CUYAMA BASIN GROUNDWATER SUSTAINABILITY AGENCY STANDING ADVISORY COMMITTEE MEETING

OCTOBER 28, 2021

SUBJECT: Review of Memorandum in Response to DWR's GSP Consultation Letter Dated June 3, 2021

RE: **Cuyama Basin GSA Response to DWR's June 3, 2021, Consultation Letter**

Figure 2-1. Cuyama Basin Threshold Regions

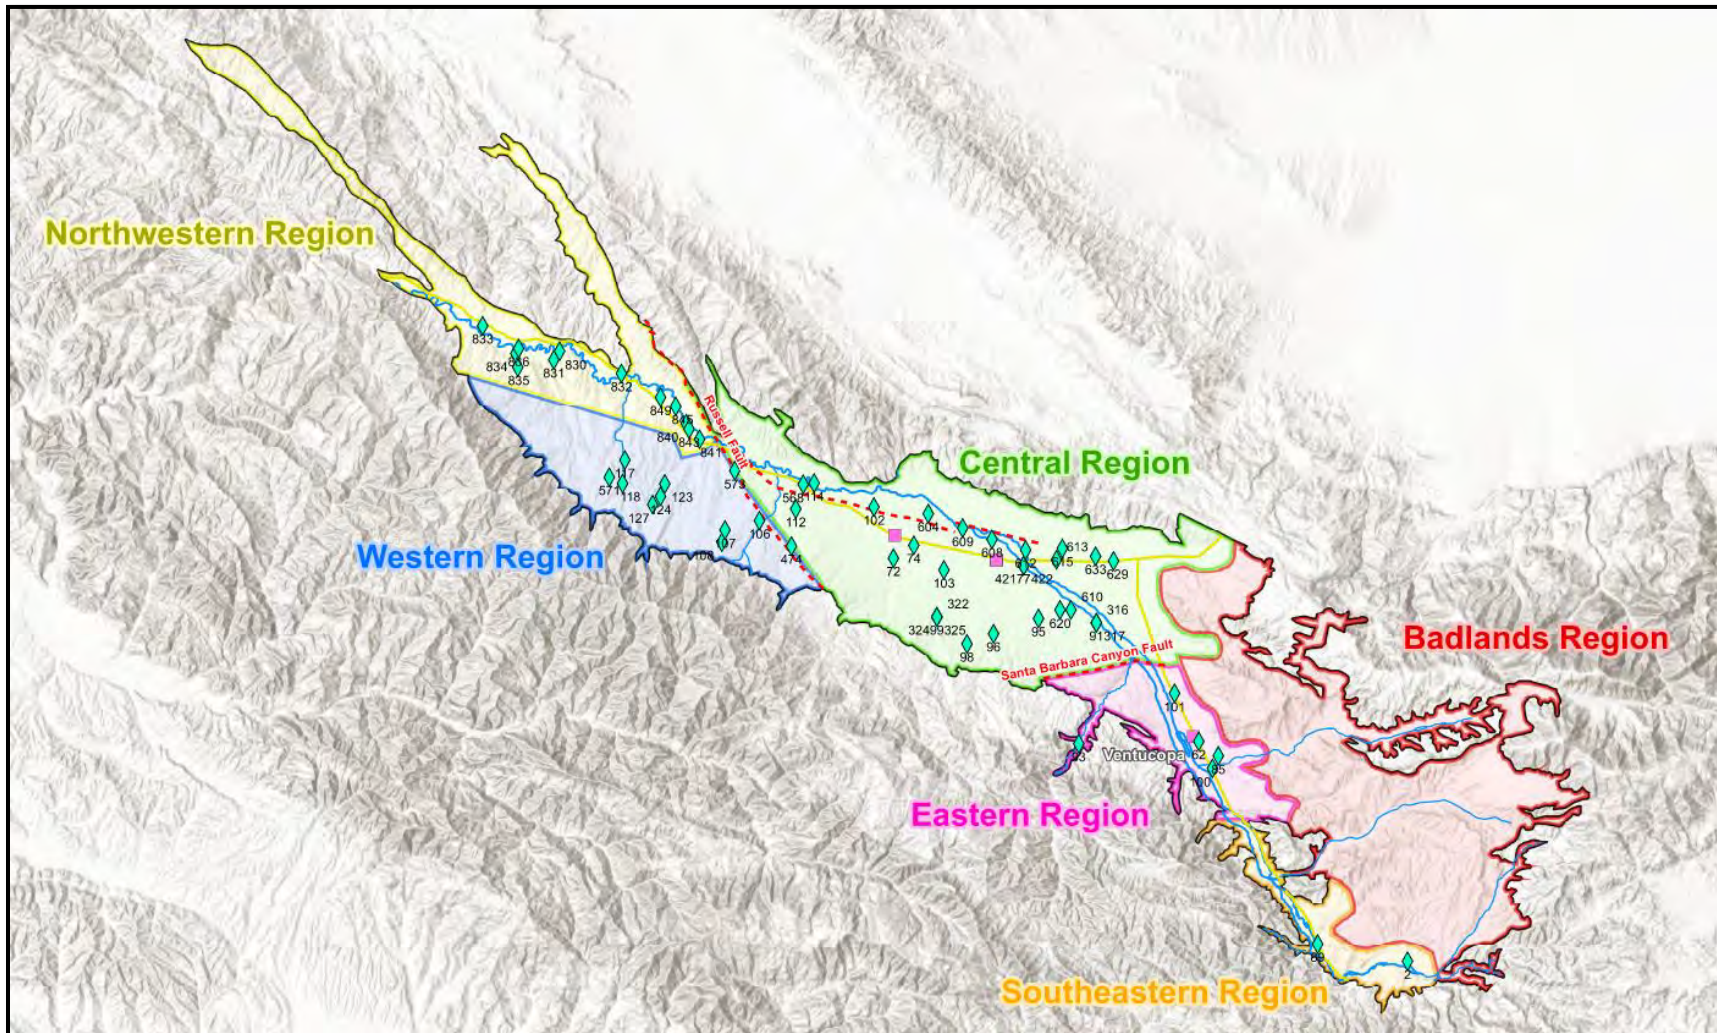
The second part of this potential corrective action seeks additional information to explain how **each threshold region's** groundwater level MTs are consistent with avoiding undesirable results, "**particularly... in the Northwestern threshold region.**" For every threshold region, DWR requests that the GSA evaluate and provide the potential effects that MTs and URs would have on:

The CBGSA developed six specific Threshold Regions for the development of thresholds for chronic lowering of groundwater levels. The six threshold regions were defined to allow areas with similar conditions to be grouped together for calculating MOs, MTs, and IMs. These threshold regions are shown in Figure 2-1, and a detailed description of each threshold region is provided in *GSP Section 5.2 – Chronic Lower of Groundwater Levels*. Table 2-12-1 provides a summary of the approach used to establish the MT for chronic lowering of groundwater levels for each threshold region.

Figure 2-3. Change in Groundwater Levels in Northwestern Region from CBWRM Test Simulation

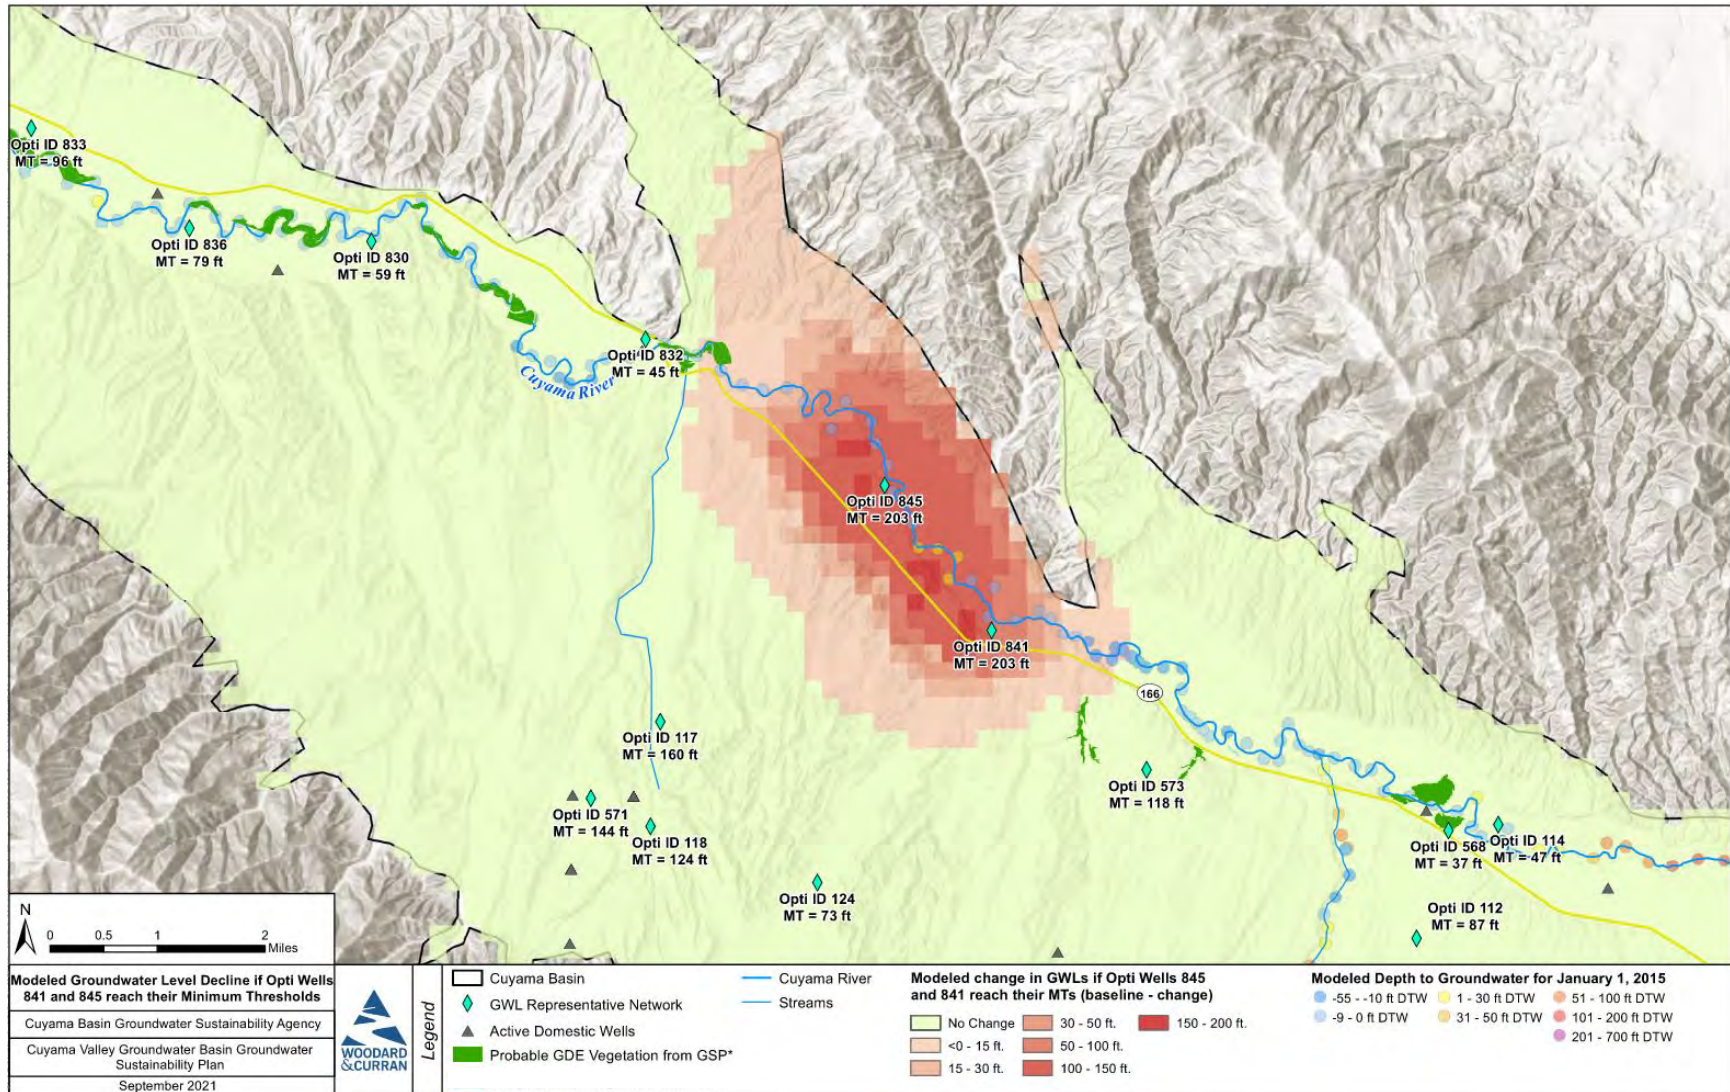
region is to “...protect the water levels from declining significantly, while allowing beneficial land surface uses (including domestic and agricultural uses) and using the storage capacity of this region.”¹² However, the Northwestern region is the only region in the Basin where the sustainable management criteria indicate a plan to substantially lower groundwater levels, relative to conditions at the time of GSP preparation (i.e., the minimum thresholds for groundwater levels are up to 140 to 160 feet lower¹³), in an area with the highest concentration of potential GDEs¹⁴ in Cuyama Valley and with interconnected surface water, which is evidenced by a gaining reach of the river.¹⁵ The GSP did not quantify the expected depletions of surface water over time or assess or disclose the anticipated effects of the established minimum thresholds on beneficial uses and users of groundwater, which, based on Department staff’s review, appear to include nearby domestic users, potential GDEs, and users of the interconnected surface water.

Figure 2-3 shows the modeled change in groundwater elevations resulting from setting groundwater levels at the minimum thresholds at wells 841 and 845. Areas shaded in red or tan color on the figure had reduced groundwater elevations as compared to the baseline condition. Areas shaded in lime green were unaffected by the change in groundwater elevations at the well 841 and 845 locations. As shown in the figure, there are no active domestic wells within the area affected by the lowered groundwater elevations at wells 841 and 845. The only GDE which may be affected is the GDE located at the confluence of Cottonwood Creek and the Cuyama River, which has an expected impact of less than 5 feet. However, even with this difference the estimated depth to water at this GDE location would be shallower than 30 feet. Potential impacts on this GDE location will be monitored at nearby Opti well 832.

As noted above, the other potential beneficial use that may be affected comes from Cuyama River inflows into Lake Twitchell. The model simulation also showed an increase in stream depletion in the affected portion of the aquifer of about 1,200 acre-feet per year. This represents about 12 percent (out of 10,200 afy) of the modeled streamflow in the Cuyama River at this location during the WY 2011-2020 model simulation period. However, the actual change in inflows into Lake Twitchell would be less than 1,200 afy because of stream depletions that would occur between Cottonwood Creek and Lake Twitchell. For comparison, during the same period the USGS gage on the Cuyama River just upstream of Lake Twitchell (11136800) recorded an average annual flow of 7,900 afy, only a portion of which comes from the Cuyama Basin. Given the lack of data regarding the hydrology and stream seepage between Cottonwood Creek and Lake Twitchell, it is uncertain how much of an impact this would have on the flows that ultimately are stored in Lake Twitchell.

Figure 3-1. Potential Stream Interconnectivity using Historical Modeled Groundwater Levels in January 2015

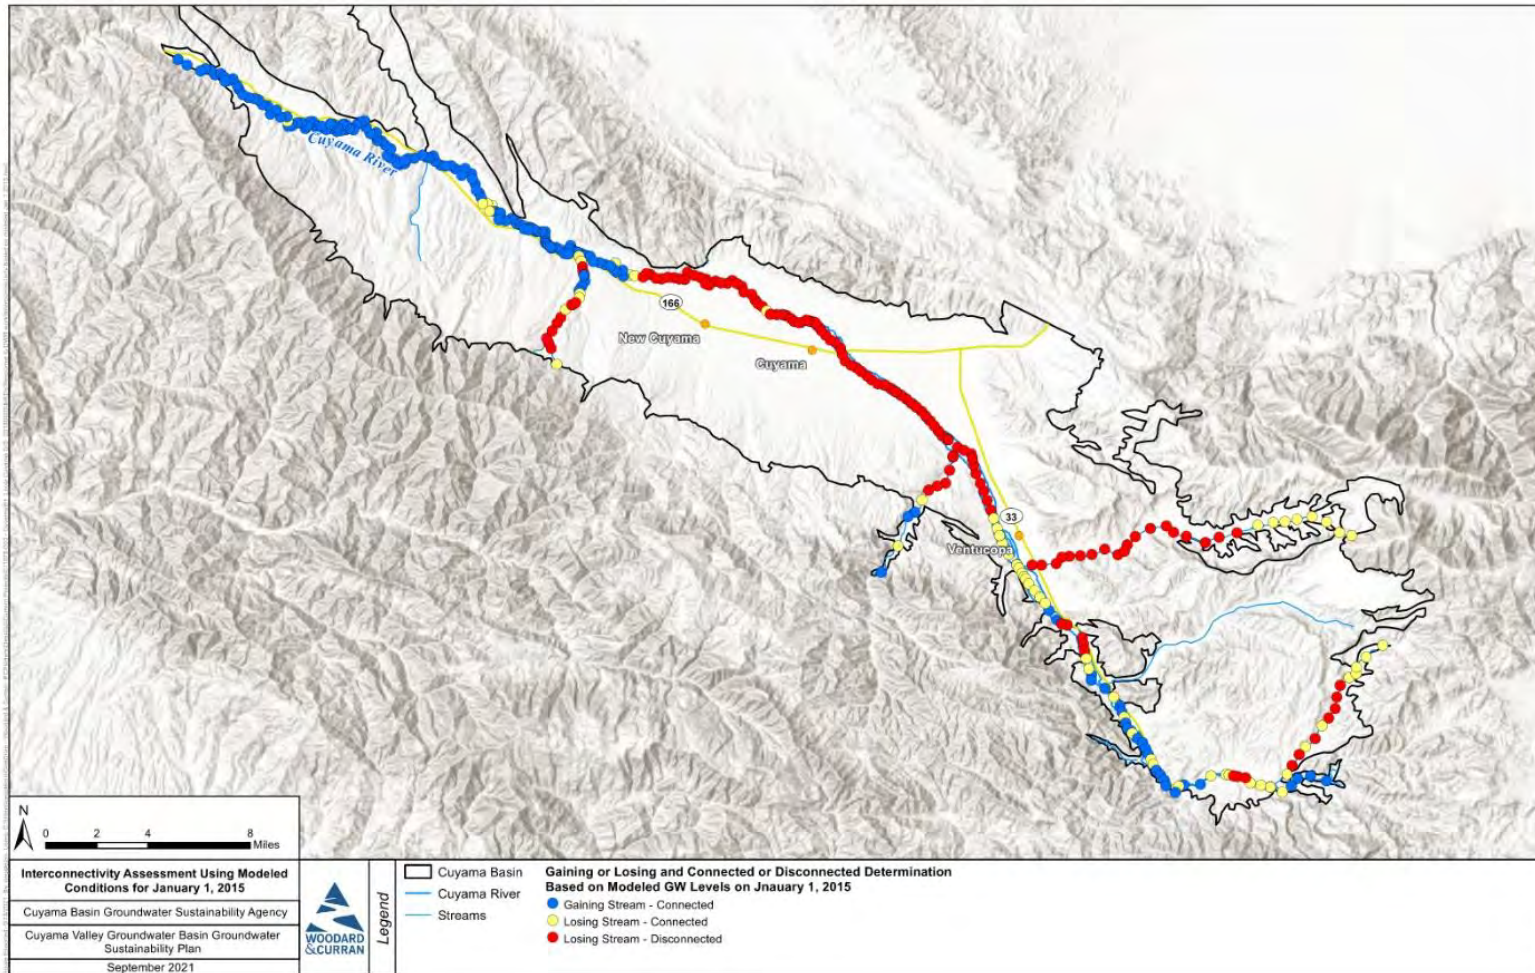
- DWR Direction:
 - Provide a demonstration, with supporting evidence, for why using the basin-wide groundwater level minimum thresholds is a reasonable proxy for thresholds for depletions of interconnected surface water
- CBGSA response includes development of a monitoring network specifically for interconnected surface water

Depletions of ISW are related to chronic lowering of groundwater levels via changes in the hydraulic gradient. Therefore, declines in groundwater elevations in portions of the river system that are hydrologically connected to the river system can lead to increased depletions of surface water. As shown in Figure 3-1, an analysis of the results of the historical simulation of the Cuyama Basin Water Resources Model (CBWRM) reveals that many portions of the stream system in the basin were already disconnected as of 2015 and therefore ISW flows in these stream reaches would not be affected by changes in groundwater levels. The primary areas of concern for ISW are on stretches of the Cuyama River upstream of Ventucopa and downstream of the Russell Fault.

Because the Cuyama River does not flow during most days of the year and the river is not subject to environmental flow regulations, the primary beneficial uses of Cuyama River streamflows are GDEs and water users who utilize water

that may flow into Lake Twitchell downstream of the basin boundary. Lowering groundwater levels could result in reduced streamflows for beneficial use by these users. Therefore, the intent of the ISW monitoring network and sustainability criteria is to ensure that long-term groundwater level declines do not occur in the vicinity of the connected stretches of the Cuyama River.

Figure 4-1. Average Well Measurements of Nitrate (as N) from 2010 through 2020

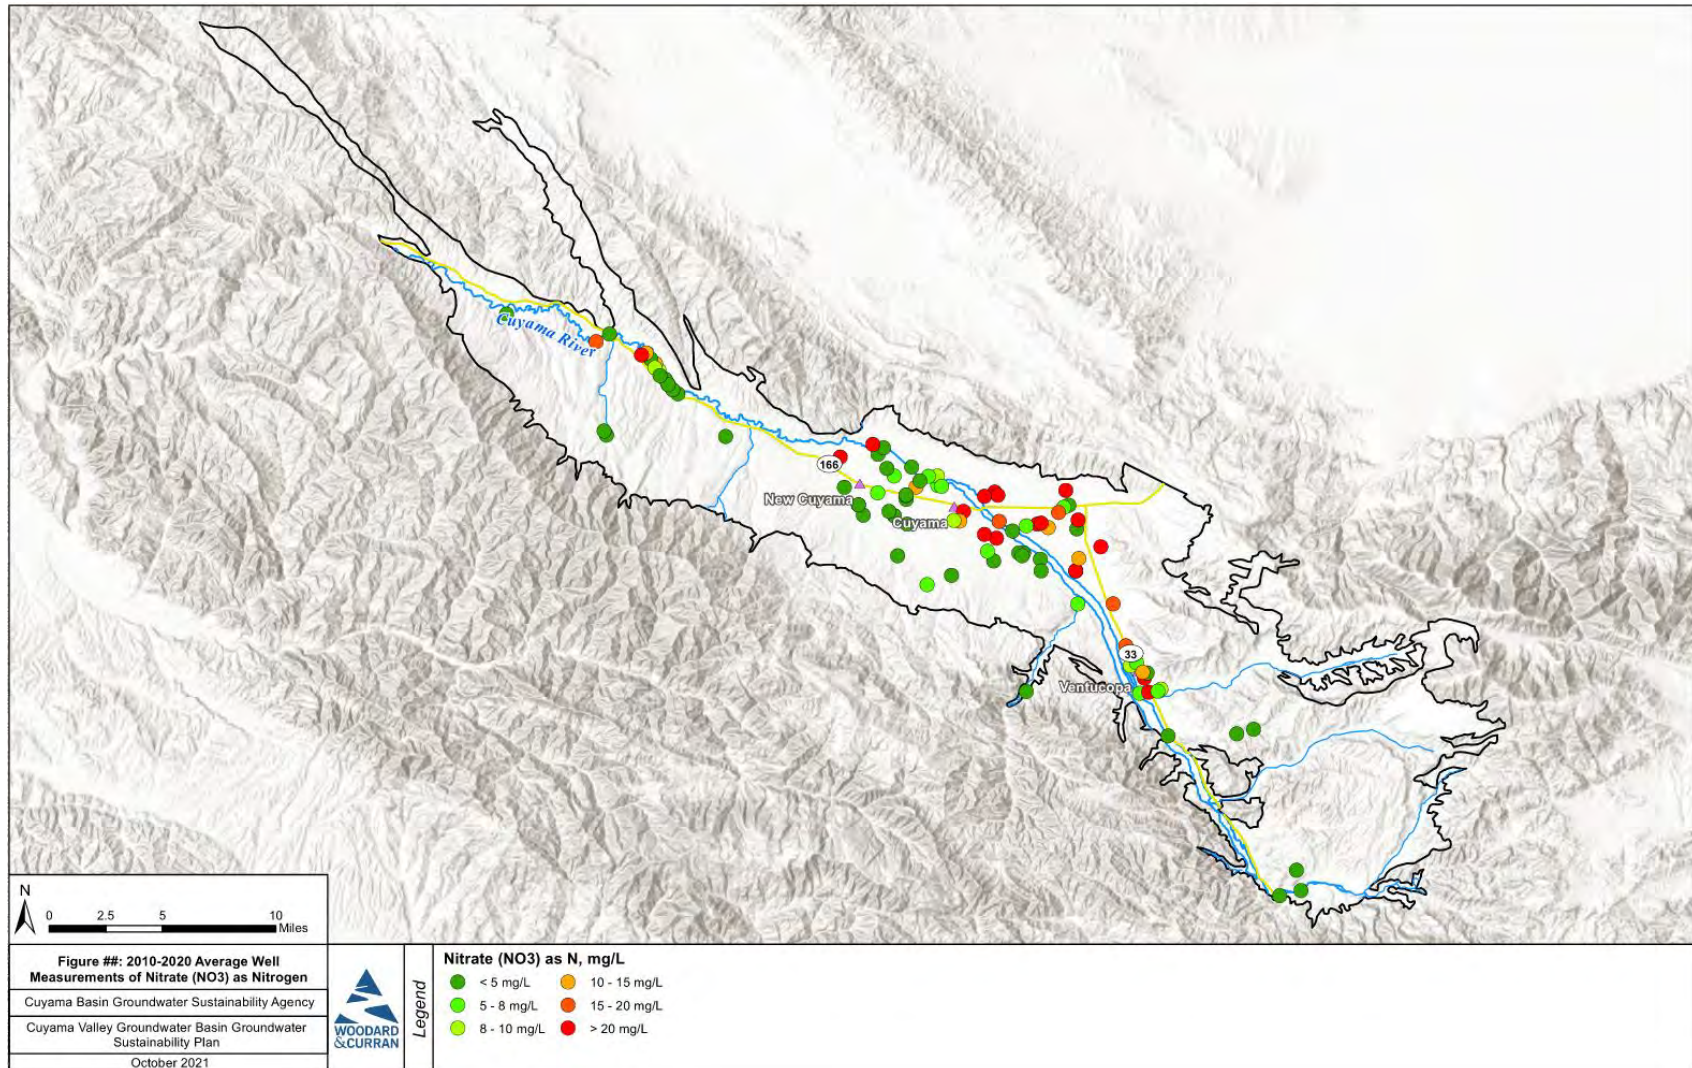
DWR's Letter expressed two main concerns about the water quality analysis and constituent thresholds used in the GSP. First, the GSP acknowledges that nitrate and arsenic have been historical constituents of concern, but due to regulatory limitations, did not set thresholds for these two constituents. Second, based on feedback provided in a public comment, there was concern that some public data was not included in the water quality analysis conducted for the Basin. DWR believes that the GSA may have approached the management strategies differently (through setting thresholds for these constituents) if this data had been utilized. DWR recommended the following to address the concerns raised in the letter:

- Groundwater conditions information related to water quality should be updated to include all available data, in particular as recommended by the Regional Water Quality Control Board, so as to reflect the best available information regarding water quality.
- The GSA should either develop sustainable management criteria for arsenic and nitrate or provide a thorough, evidence-based description for why groundwater management is unlikely to cause significant and unreasonable degradation of groundwater.
- The GSA should appropriately revise its monitoring network based on the above updates. At a minimum, the GSA should include monitoring for arsenic and nitrates as they have been identified as constituents of concern in the basin.

As shown in Figures 4-1 and 4-2, most wells with nitrate and arsenic concentrations exceeding MCLs are located in the central threshold region. The locations of high arsenic concentrations are focused to the south of the town of New Cuyama near the existing Cuyama Community Services District (CCSD) well. This is a known issue for the CCSD that will be mitigated by the construction of a replacement well for the district, which was included as a project in the GSP (see section 7.4.4).
